REPORT TO PLANNING COMMISSION

CITY OF ARNOLD

APPLICATION NUMBER: 2019-44

APPLICATION NAME: ROCK TOWNSHIP AMBULANCE BUILDING
COMMERCIAL SITE PLAN

SITE AND CROSS SECTION SCHEMATIC

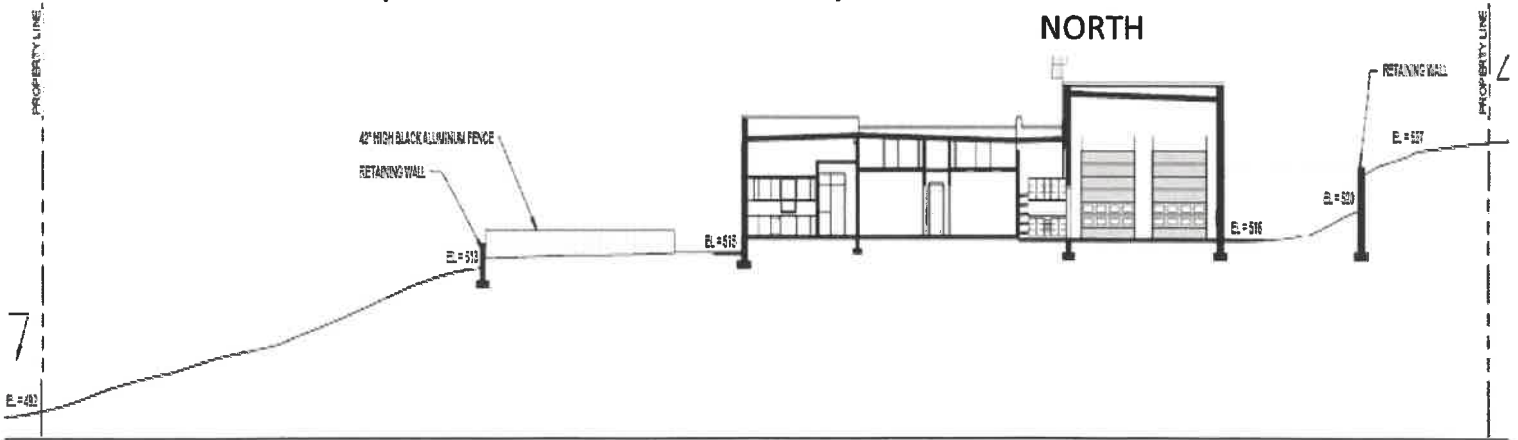
Regarding circulation, the ambulance vehicles will enter the west drive, then route to the rear u-drive and park within the garage. Further, both the west and east drives exceed minimum width standards to provide ingress and egress at both locations. That being said, the curb cuts are located as such that exiting vehicle head lights are not directly glaring at the front of homes across the street. This is depicted within the Site and Cross Section Schematic, page 4.

SITE PLAN WITH GRADING, PAVING AND UTILITIES

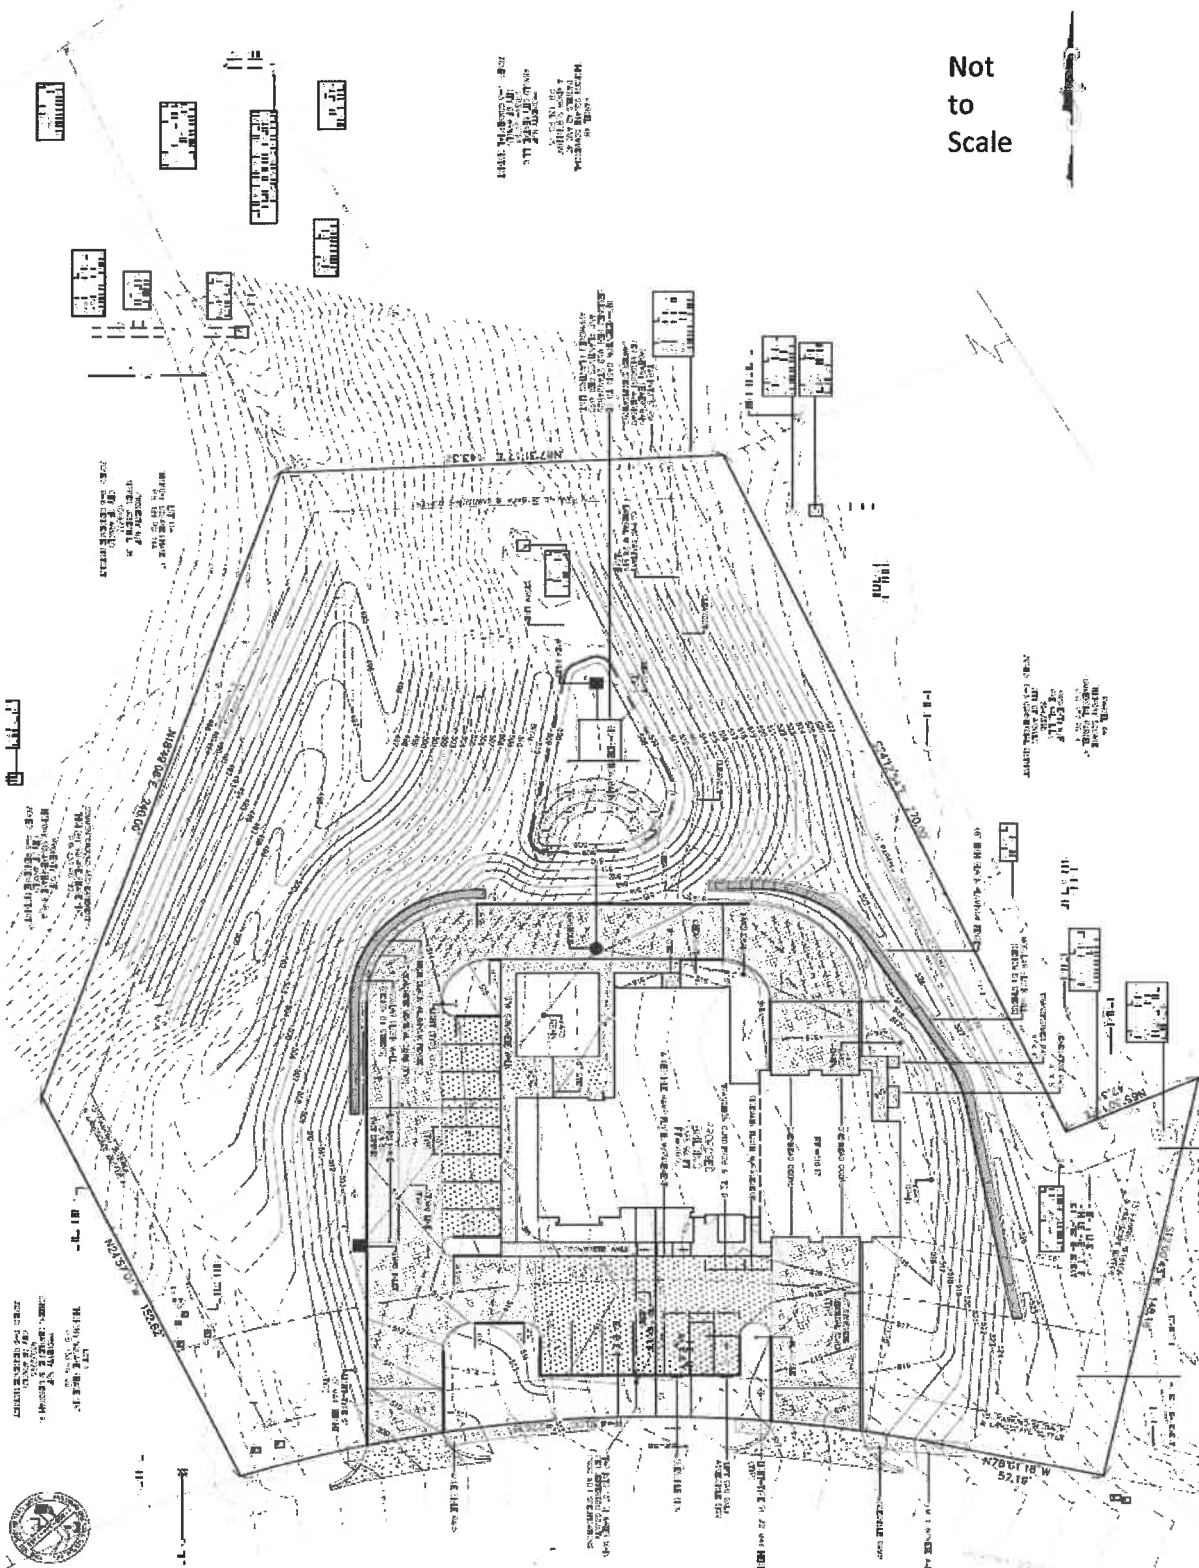
Based on staff review of the use and daily occupants, 5 spaces are required; however 14 spaces with dimension of 10ft by 19ft are being provided. This includes a regular and van accessible ADA space and access aisle. Parking is sufficiently met as shown in the Site Plan, page 6.

There is an above ground detention basin for stormwater volume, which services this commercial subdivision and lot. Within the City stormwater code there is the requirement to "retrofit" the storm system to fulfil the need for stormwater quality. As shown on page 8, the site plan included a bio-retention basin providing for this necessary condition.

LANDSCAPE PLAN

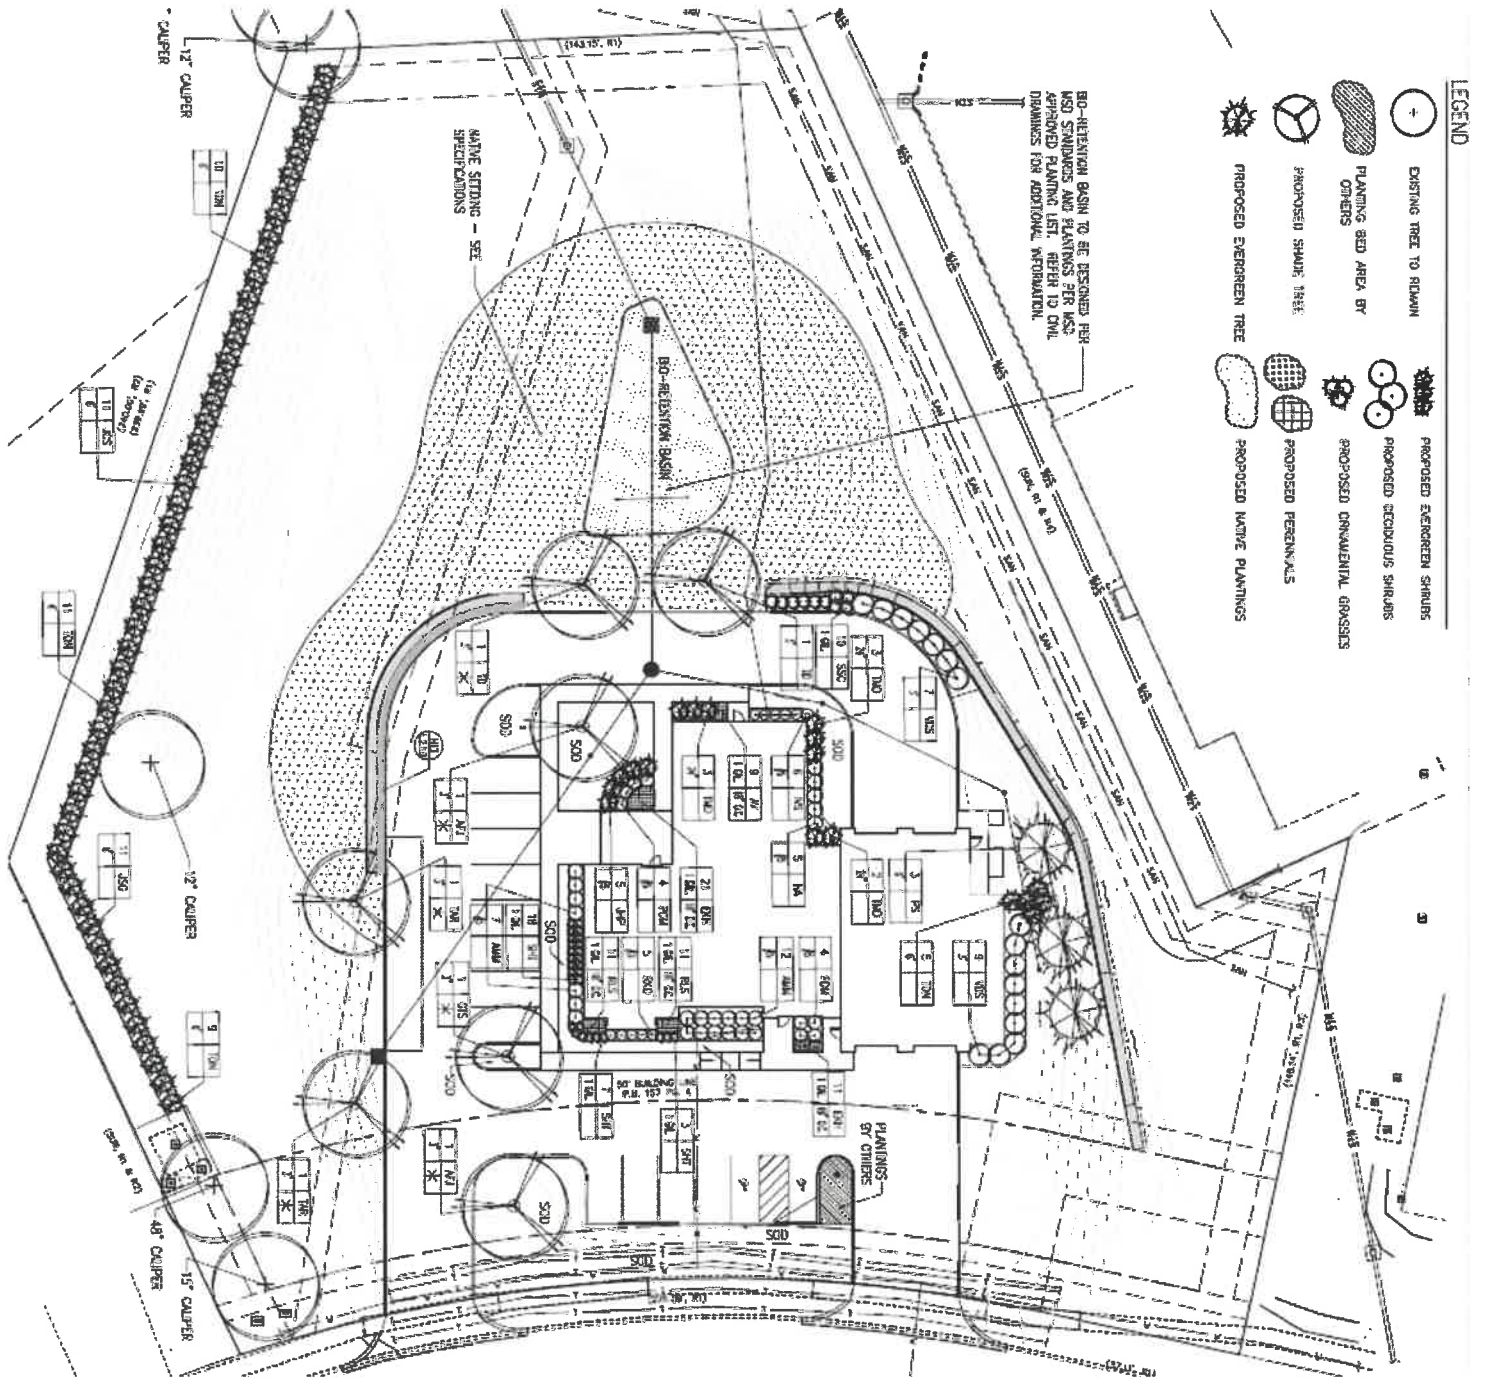
The open space and landscape for the Ambulance House far exceeds the zoning code minimums. As presented on page 6 of this report, 72% of the site will be green space and landscaped where the minimum by code is 15%. The number of trees and plantings are consistent with code requirements and a variety of shrubs, ornamental grasses and perennials are proposed. Included as part of the landscape plan is native seed mix to be used in and around the bio-retention basin. The necessary landscape buffer is proposed within the 15' wide easement along all property lines adjacent to residential district. As well as irrigation will be installed at all planting beds.

ARCHITECTURAL ELEVATIONS

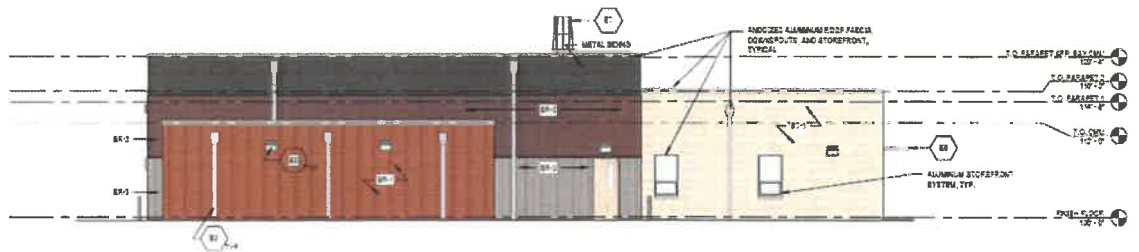
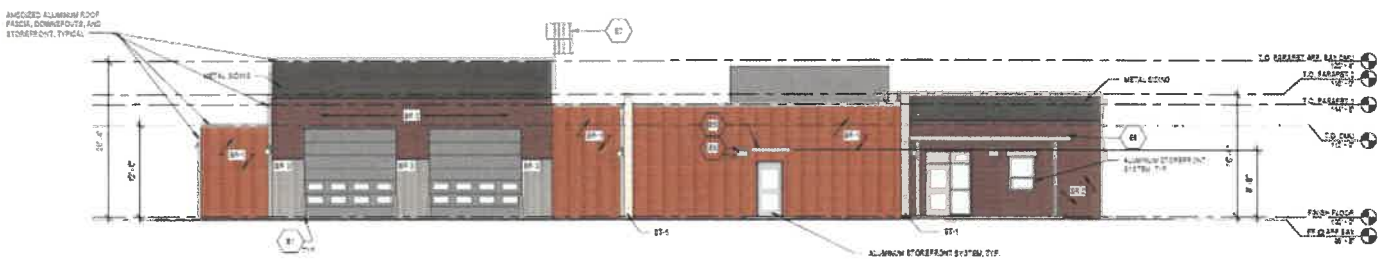
As shown on the perspective and described in the general elevation notes; all architectural styling features and colors are presented. All materials include a combination of brick face, stone cladding, accent brick, metal siding and trim. The rooftop will be screened to completely conceal all roof mounted equipment. Building elevations with material description along with a legend of colors are included on page 9 and 10 of this staff report.
